Re: Submission on a publicly notified Plan Change-Plan Change 50

IN THE MATTER of the Publicly Notified Plan Change
50

Plan Change 50 Queenstown Town Centre Zone Extension

SIGHT LINE ANALYSIS MAN STREET CAR PARK SITE

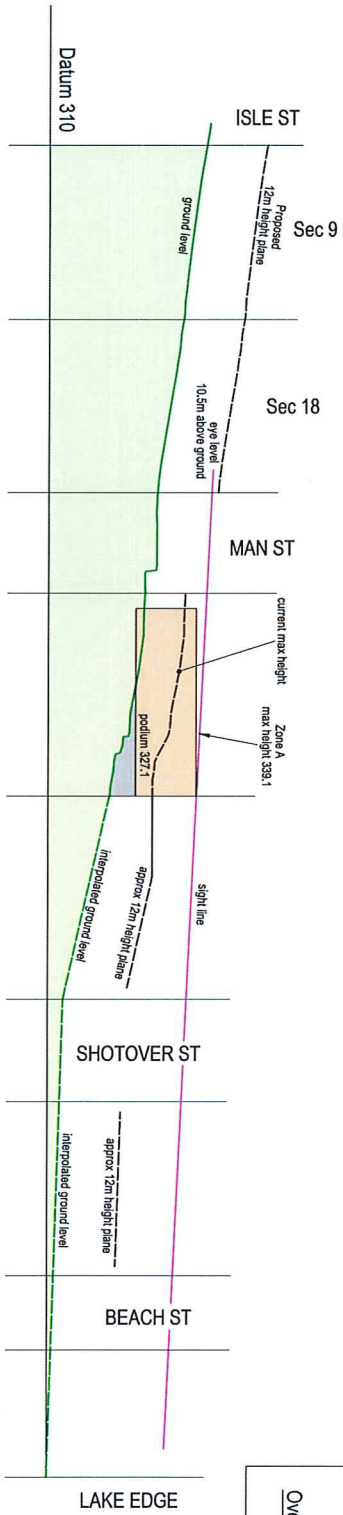
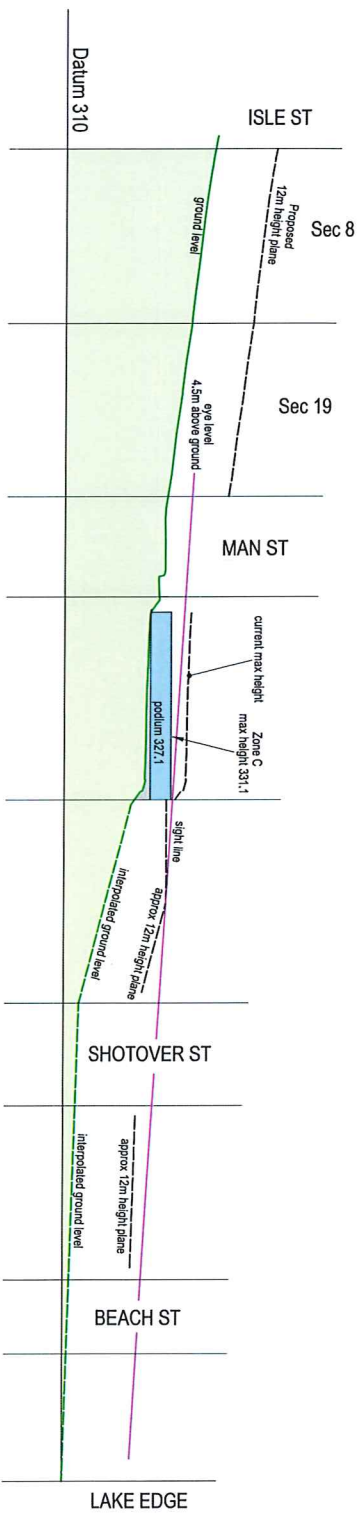
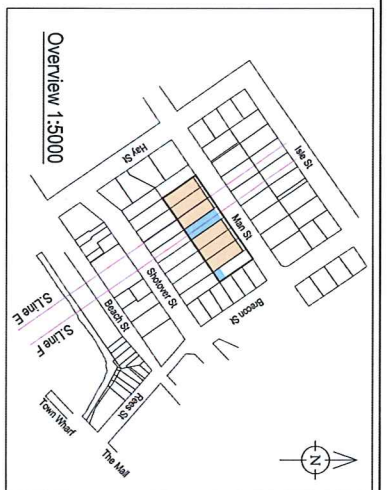
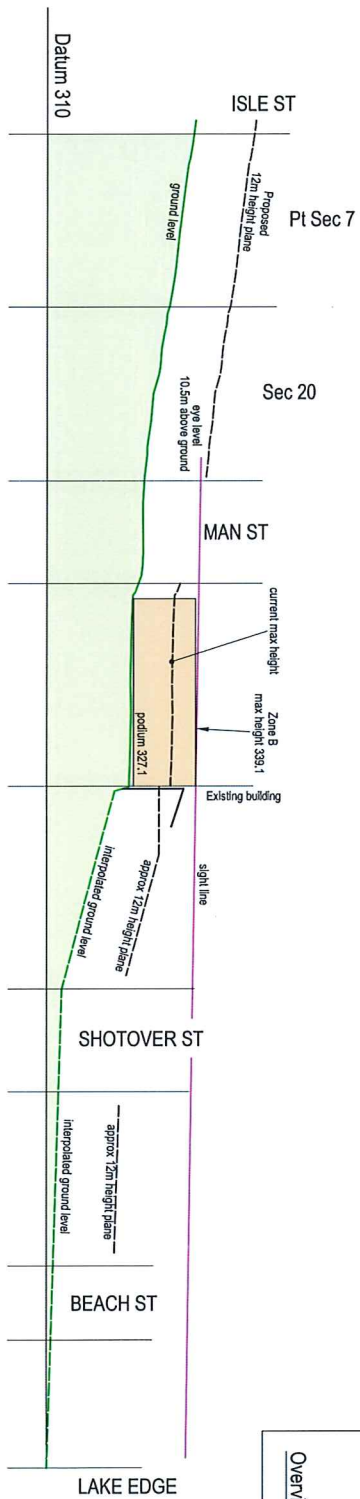
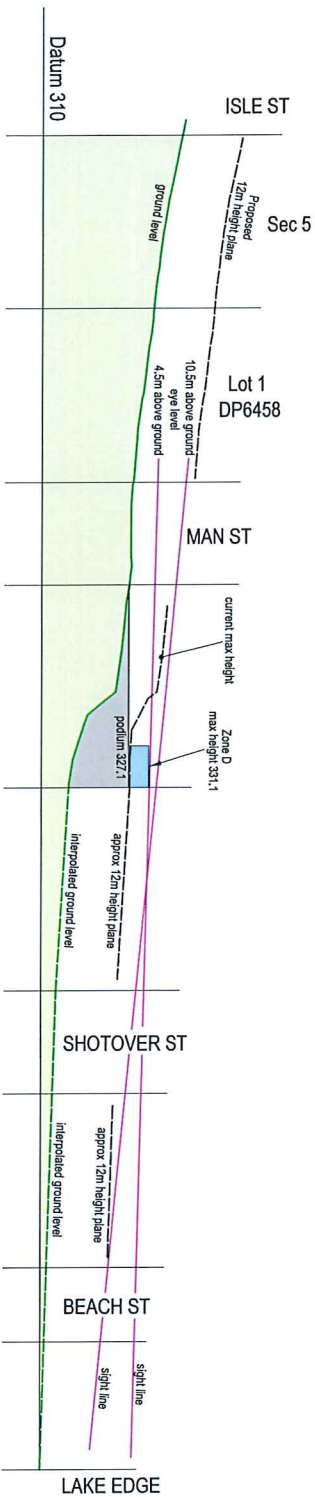
Further to the above, the submitter believes that a 12 metre building height limit from 327.1m is appropriate for two areas of the site, being referenced as Zones A and B (maximum height being 339.1m). Zones A and B are two roughly square areas. This recommended height limit is less than what is proposed within the Isle Street Sub-Zones in terms of Plan Change 50.

The proposed height limits outlined above are illustrated on the attached plans compiled by Aurum Survey Consultants Limited.
